Delegated Report

Householder Planning Application

Planning Application No: 20240407

Description: Installation of a dropped kerb. Removal of grass verge to gain access to driveway at front of property.

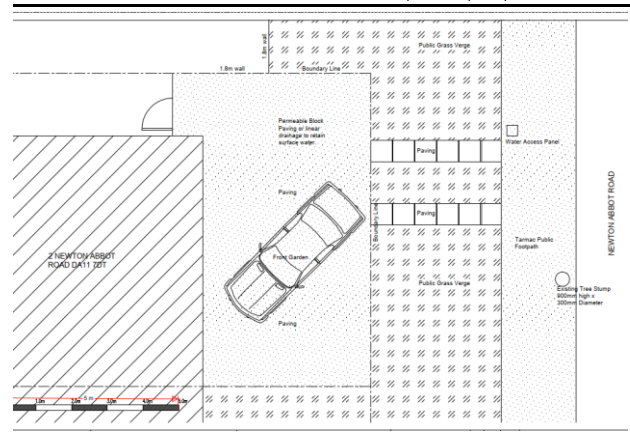
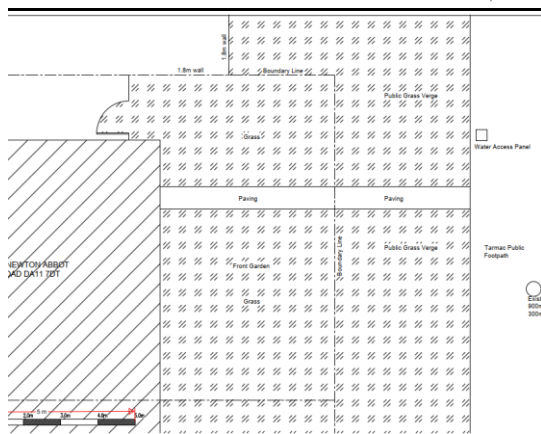
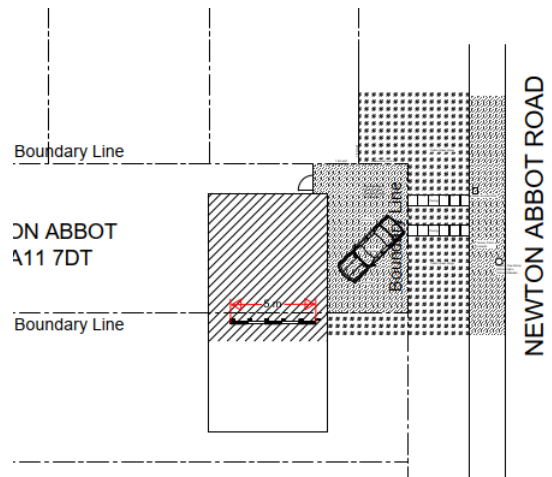
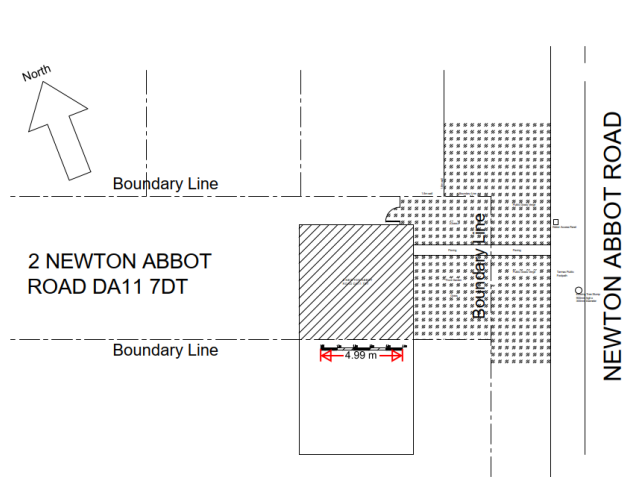
The proposal would seek to remove two strips measuring approx. 0.6m x 3.65 m of the grass verge and would involve removing all of the soft landscaping and replacing it with hard paving to facilitate off road parking for two vehicles. The driveway will have a depth of some 4.7m and a width of 8.7m.

It is acknowledged that the applicant has attempted to lessen the loss of the grass verge by resorting to tyre tracks instead of a large section of grass however this is still considered to be interrupt the grass verge and damage the character and appearance of the street scene.

The proposal also seeks to entirely remove the soft landscaping to the property frontage and replace it with a hardstanding. Below is an extract from the Council's adopted design guidance:

The hardstanding is insufficient and contrary to the Kent County Council's parking standards (SPG 4) which states a space should have a minimum depth of 5m and a minimum width of 2.5m. It is evident that adequate parking cannot be achieved to the front of the property and as a result - as can be seen with the existing parking arrangement – there will be an overhang onto public highway land which is unacceptable. As such the application is contrary to the minimum depth stated in KCCs parking standards (SPG 4) and cannot be supported on highway grounds.

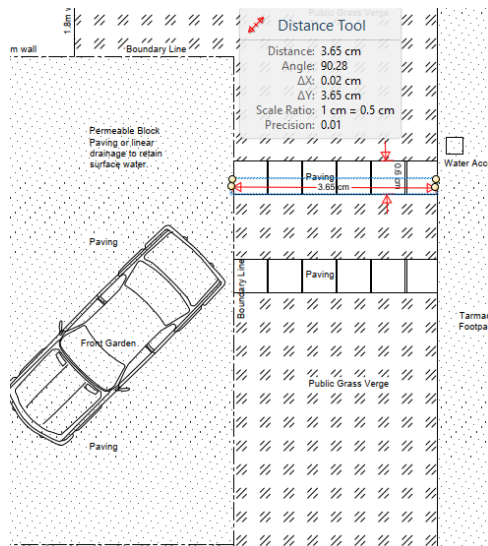
The application site is a two storey semi detached dwelling, the property is set back from the main highway and has a grass verge separating it from the pedestrian footpath. At present the frontage appears to be utilised as an off-road parking area which involves the occupants mounting the kerb and driving over the grass verge.

It is noted that No.1 Newton Abbot Road, has removed some of the soft verge to the front of their property, however this appears to be more of a pedestrian access.
